Access Compliance Report

Public Rights-of-Way

Intersection ID: 11306	Main Street: W_9TH_ST	Cross Street: N_SMITH_ST	Location: S
ADA ID: 4FAC4F54F76F	Ramp Type: PerpDiag	Initial Pass/Fail: Fail	Overall Compliance: No
		Severity Score: 12.5

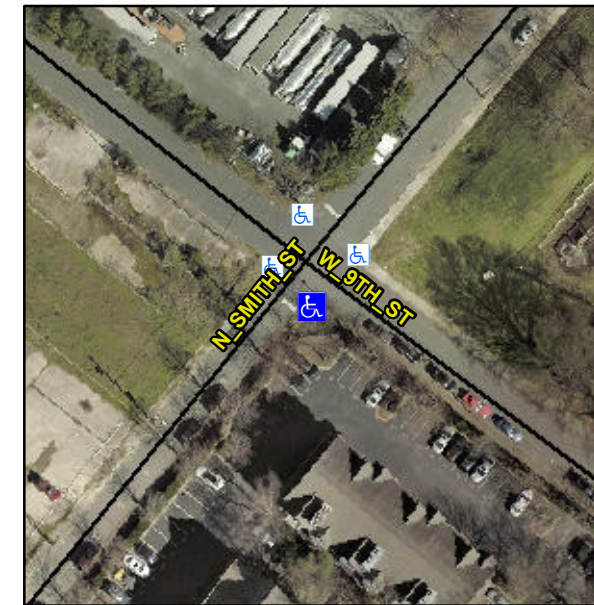
Not Found, R304.2.2

Compliance	Description	Data	Compliance	Description	Data
N/A	Ramp Length (in)	58.0	No	Ramp Slope (%)	9.8
Yes	Ramp Width (in)	72.0	Yes	Ramp XSlope (%)	0.0
N/A	Flare Type LT	N/A	N/A	Flare Type RT	N/A
N/A	Flare Slope LT (%)	N/A	N/A	Flare Slope RT (%)	N/A
N/A	Flare Traversable LT?	N/A	N/A	Flare Traversable RT?	N/A
N/A	Landing Length (in)	N/A	N/A	DWS Provided?	N/A
N/A	Landing Width (in)	N/A	N/A	DWS Contrast?	N/A
N/A	Landing Slope (%)	N/A	N/A	DWS Length (in)	N/A
N/A	Landing X Slope (%)	N/A	N/A	DWS Full Width?	N/A
N/A	Landing Curb? (Y/N)	N/A	N/A	DWS Offset (in)	N/A
N/A	Shared Landing?	N/A			
N/A	Gutter Ponding?	Yes	N/A	Gutter Slope (%)	N/A
N/A	Gutter Lip Ht (in)	N/A	N/A	Gutter X Slope (%)	N/A
N/A	Painted X Walk1?	No	N/A	Painted X Walk2?	No
	X Walk 1 Direction	To NE		X Walk 2 Direction	To NW
N/A	X Walk 1 Width (in)	N/A	N/A	X Walk 2 Width (in)	N/A
	X Walk 1 Slope (%)	1.2		X Walk 2 Slope (%)	0.3
	X Walk 1 X Slope (%)	2.3		X Walk 2 X Slope (%)	0.3

Remove & Replace Curb Ramp With Two New Directional Ramps or Equivalent.
